Sub: Interpretation of OLS Allowable Infringement Circular dated 26/03/2015

Sub: Interpretation of OLS AGA Circular dated 26/03/2015

**EXHIBIT 1 - NEW AGA ALLOWABLE INFRINGEMENT ALLOWABLE LIMIT
CALCULATION ANALYSIS**

Minutes of the Meeting with CREDAI (Confederation of Real Estate Developers Association of India), NAREDCO (National Real Estate Development Council) and PEATA (Practicing Engineers, Architects and Town Planning Association India) on 7th August 2018 at Rajiv Gandhi Bhawan, AAI HQ, New Delhi to discuss interpretation of “Guidelines on Allowable Penetration of OLS in Aeronautical Study Reports”.

Safety study - Recommendations:

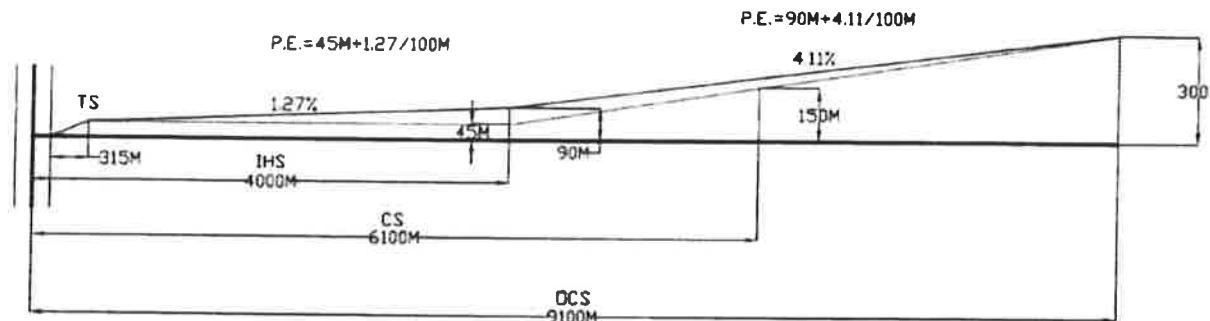
- 1) In IHS higher heights penetrating OLS to be restricted in the slope of 1.27% from end of the Transitional surface upto the maximum height of 90 m above Aerodrome Elevation
- 2) In continuation thereto in the conical surface including outer conical surface the heights penetrating OLS to be restricted in the slope of 4.11% from the end of the IHS upto the maximum height of 300 m above Aerodrome Elevation

1. Within Inner Horizontal Surface (IHS) area:

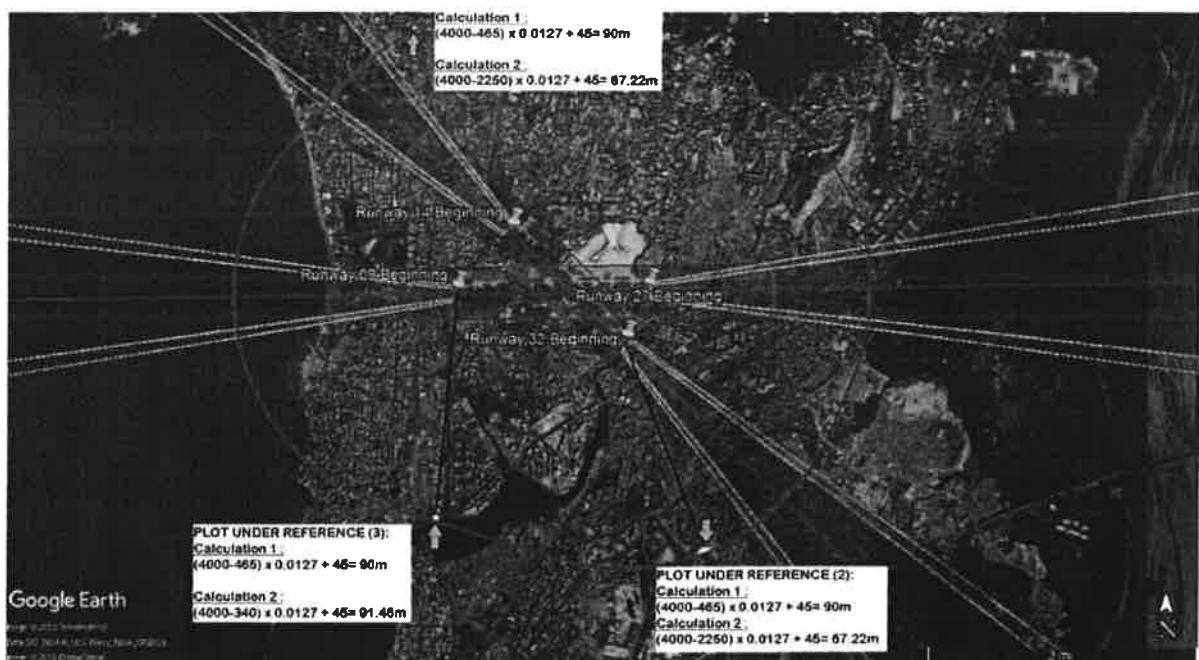
The allowable AGA infringement limitation is calculated based on permitted permissible progressive height of 90m (at inner Horizontal surface (IHS) - end point from 45m IHS permitted normal height at transitional surface end point i.e., central rectangular area 465m point (150m Runway strip + 315m of transitional surface reaching 45m height at 14.3% slope of transitional surface).

The Arrived Slope is = $(4000m - 465m) \div (90m - 45m) = 3535m \div 45m = 0.0127 = 1.27\%$

In order to allow permitted height of 90m at 4km i.e., end of Inner Horizontal Surface (IHS), only 465m to be deducted from perpendicular distance in central Rectangular area and Radial distance from both semi-circular areas on approach side. Any other deduction from radial distance will deviate from Safety Assessment allowed permissible infringement limit slope calculation.

Otherwise, allowed infringement height of 90m will no longer arrived at the end of IHS in the semicircular area on approach side, which is covering 2/3 of IHS area. (Diagram with example shown below for ready reference).

- Hence, earlier used formula i.e., $PE = \text{Aerodrome Elevation} + 45 + (1.27 \times (\text{Distance of nearest runway extremity} - 465) / 100)$ for maximum allowable AGA OLS obstacle penetration limit is valid for semicircular approach areas.
- However, only central rectangular area portion needs to be reviewed by considering perpendicular (Lateral) distance from respective point along the transitional surface as depicted in the safety assessment permissible slope diagram

Analysis - Technical consideration:

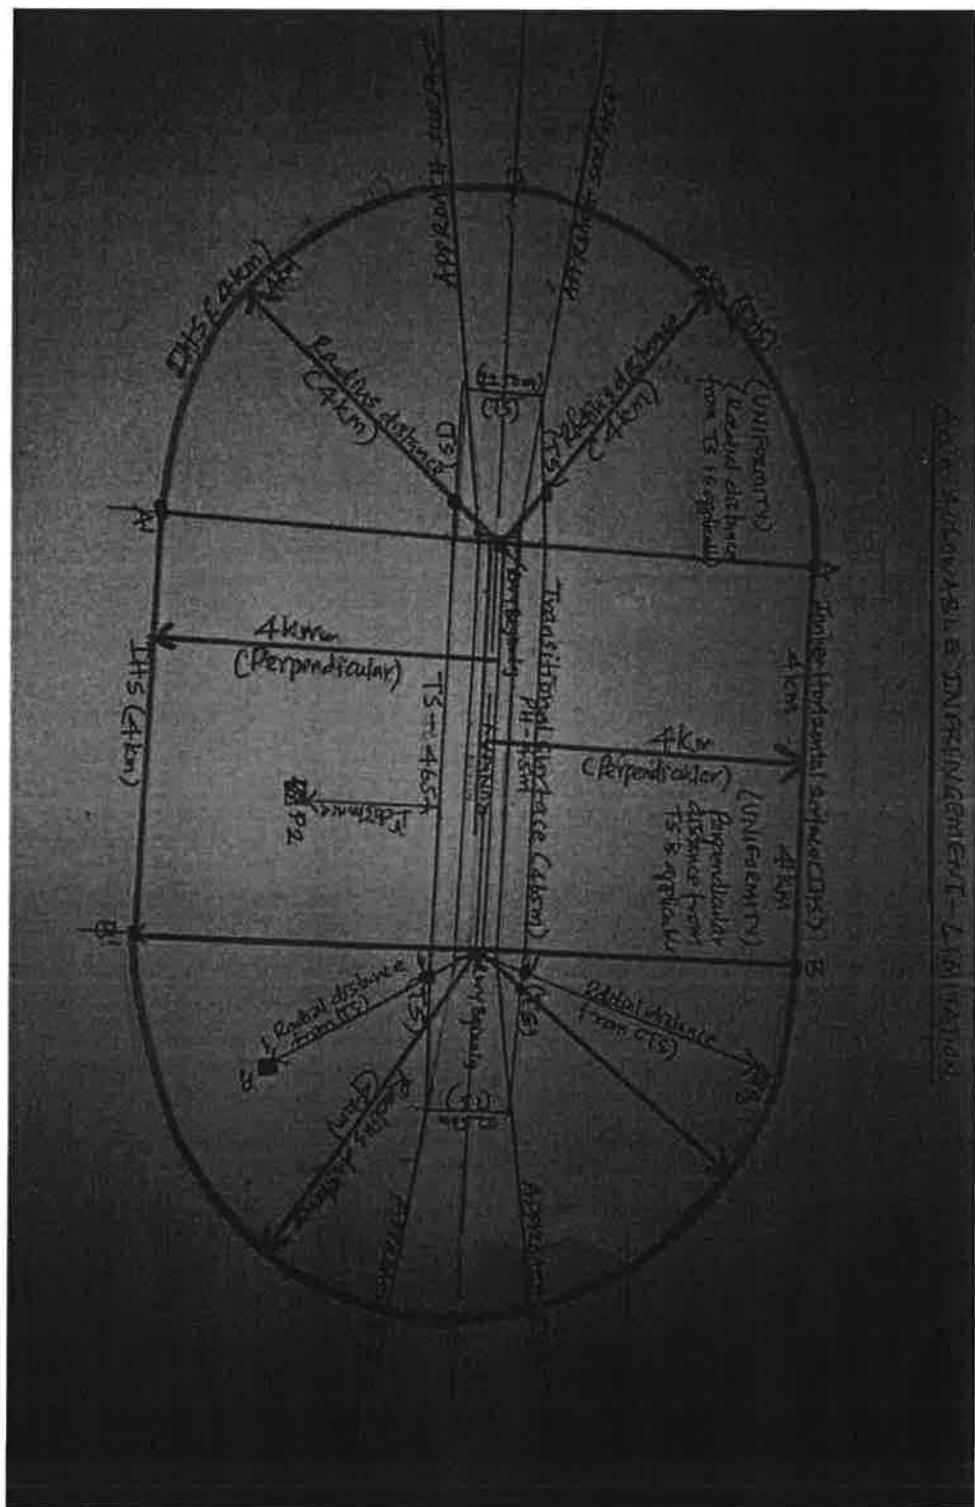
Transitional surface is continuing up to Inner horizontal surface. The transitional surface ends at 45M height in all direction from runway strip (150m point).

- The central part is considered 4km perpendicular to runway centerline – i.e., between runway beginnings. The shortest distance is lateral (Perpendicular) distance from transitional surface (465m point).
- In central portion (465m) due 14.3% (1:7) slope applicability. (Between Beginning of the runways),
- Hence, Lateral (Perpendicular distance from Transitional surface is applicable for AGA Allowable Infringement Calculation

- The Inner Horizontal surface is drawn 4 km radius distance from runway beginning point.
- Before the beginning of runways due to applicability of 2% (1:50) & 14.3% (1:7)slope, Approach surface distance of 2250m from beginning of runway.
- The transitional surface ends at 2250m in the approach section.
- There is no Transitional Lateral reference after 2250m.
- **Only Radial reference distance from transitional surface is applicable with respect to Geometrical Configuration of Inner Horizontal Surface (IHS) and to meet with the study objective of gradual and uniformity as the distance of the object from the Airport Runway End increases.**

However, it APPEARS new calculation considering only lateral shortest distance from Transitional surface for all the sections. (Beginning (Radial) + Central (lateral) + Beginning (Radial), instead of radial distance from transitional surface in the approach portion. **This will not comply with objective of safety assessment study recommendation.**

CASE STUDY : RARE TOWNSHIP PVT.LTD., MUMBAI

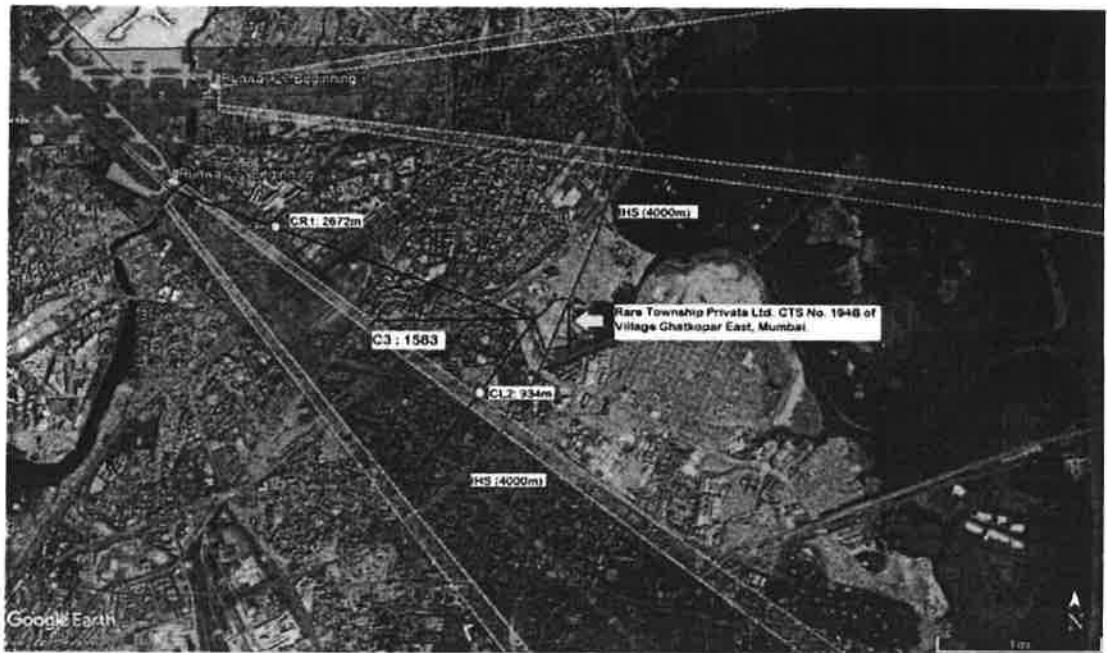
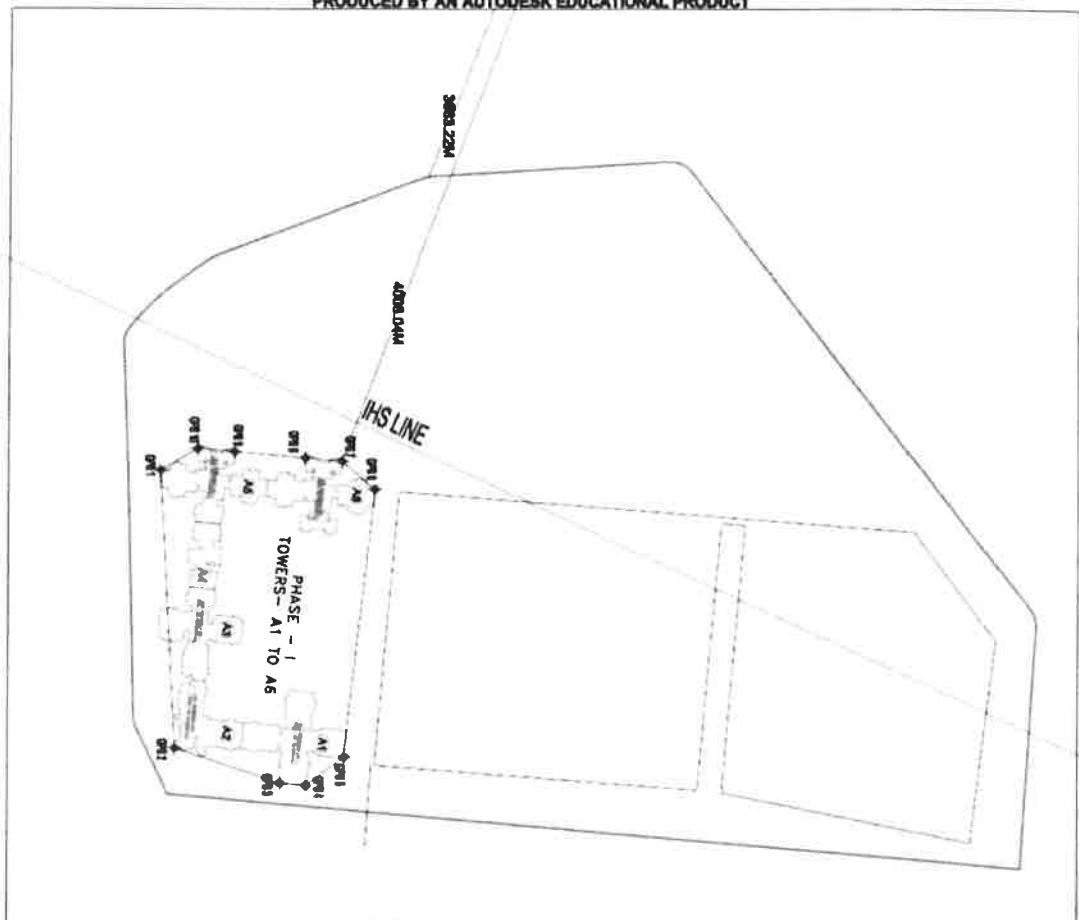
- The proposed site lies in Inner Horizontal Surface and is at a distance of 3781 m from Runway 14 beginning of Santa Cruz Airport.
- The allowable infringement = $(3781 - 465) \times 0.0127 + 56.90 = 99.01\text{m}$

- The proposed site lies in Inner Horizontal Surface and is at a shortest **Lateral distance** is of 1366 m from Runway 14/32 transitional surface.
- The allowable infringement = $1583 \times 0.0127 + 56.90 = 77.0\text{m AMSL}$

- The proposed site lies in Inner Horizontal Surface and is at a shortest **Radial distance** of 2672 m from Runway 14/32 transitional surface.
- The allowable infringement = $2672 \times 0.0127 + 56.90 = 90.83\text{m AMSL}$

Inner Horizontal Surface (IHS)

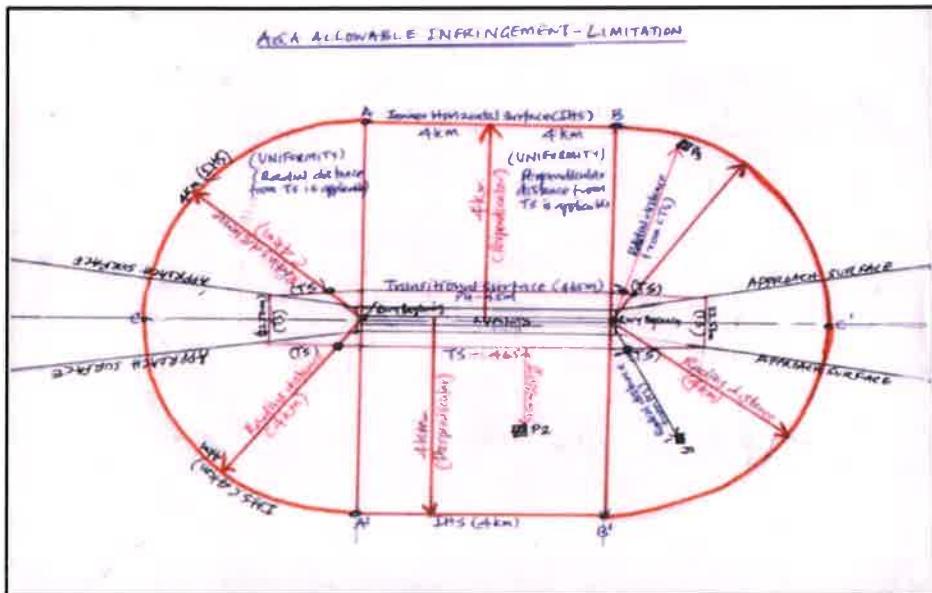
As per interpretation of CREDAI expert, in IHS the location of any site should be measured from centre of extremity of runway. IHS is circular in dimension, therefore, the applicable distance should be measured from the end of transition surface through the line connecting runway extremity and the site as shown in the figure below:

The end of Transitional Surface was shown through a diagram below:

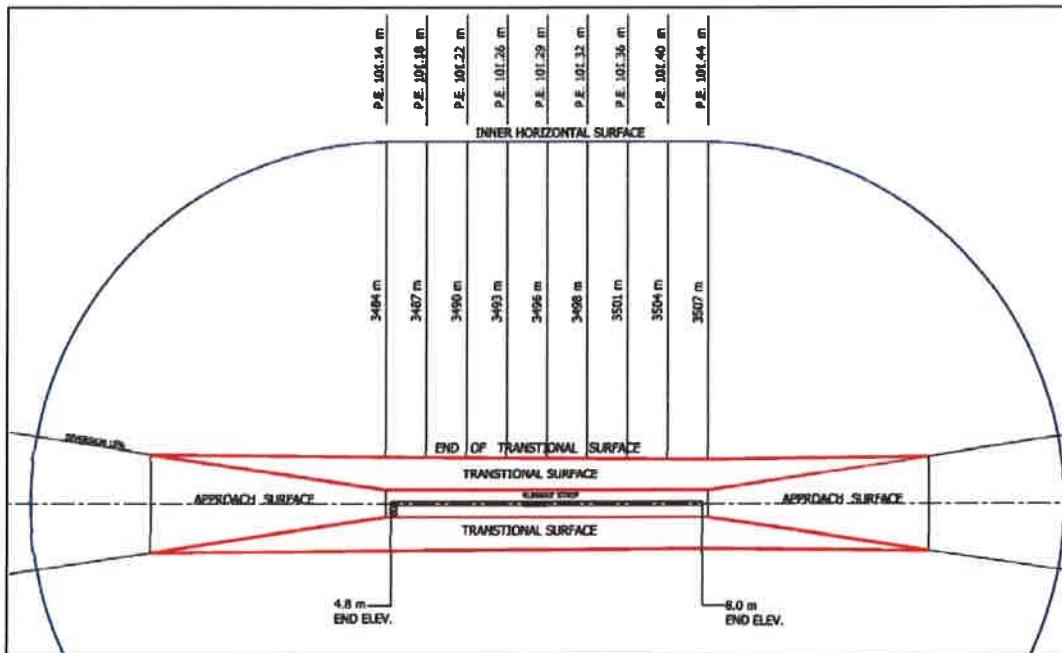
As per the guidelines, 1.27 % slope is to be drawn from end of Transitional Surface to the site in IHS upto the maximum height of 90 m above aerodrome elevation. Therefore, the reference datum is end of Transitional Surface. If we have to obtain distance between two points, it is always the shortest distance. Since reference datum is end of the Transitional Surface, line cannot be drawn from centre of runway extremity to the site. It should be drawn from end of the Transitional Surface to the site as shown in pictorial diagram below in different areas:
